HISTORIC AND DESIGN REVIEW COMMISSION

HDRC CASE NO: 2021-033

ADDRESS: 324 E ROSEWOOD AVE

TYPE OF WORK: Roof replacement APPLICATION RECEIVED: January 07, 2021

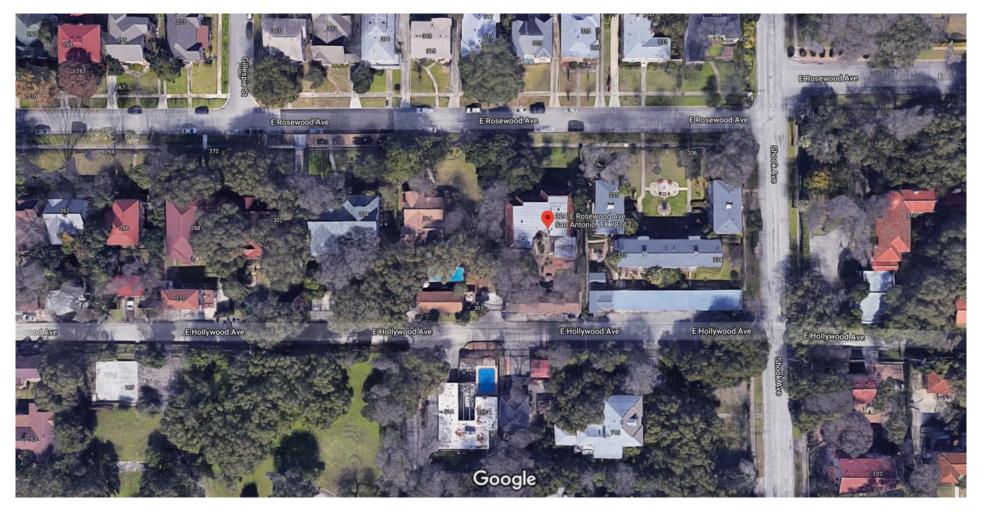
a. The primary structure located at 324 E Rosewood is a 2-story, multi-family structure constructed circa 1930. It first appears on the 1951 Sanborn map. The structure has an asymmetrical u-shape plan and features a flat roof with mansard slopes and red clay or ceramic tiles, a pitched tile porch roof, a secondary front gable porch awning, a stone veneer, and one-over-one windows. The property is contributing to the Monte Vista Historic District.

b. The applicant has proposed to replace the existing red clay or ceramic tile roof with a composition shingle roof to match other stone veneer properties on the block. Guideline 3.B.iv for Exterior Maintenance and Alterations states that roofing materials should be replaced with in-kind materials whenever possible when the roof must be replaced. Historic materials such as slate or clay tiles should be retained and re-used when large-scale replacement of roof materials other than asphalt shingles is required. The existing clay roof tiles are severely damaged and require replacement. Furthermore, Guideline 3.B.iv states that new roofing materials should match the original materials in terms of their scale, color, texture, profile and style or materials should be selected that are consistent with the building style when in-kind replacement is not possible. The 1951 Sanborn map shows that the original roof was composition; however, the Sanborn map may have referenced the material of the flat roof portion of the structure. Staff finds the request is inconsistent with the Guidelines. Staff finds that the installation of a material, such as pressed metal, that is similar in appearance to the existing tile would be appropriate.

Staff does not recommend approval based on findings a through b. Staff recommends that the roof is replaced with in-kind materials or a material similar in appearance to the existing tile.

- i. That the replacement composition shingles are similar in appearance to the existing tile and are verified by staff. The applicant is required to submit final material specifications to staff for review and approval.
- ii. That the applicant maintains the existing ridge detailing.
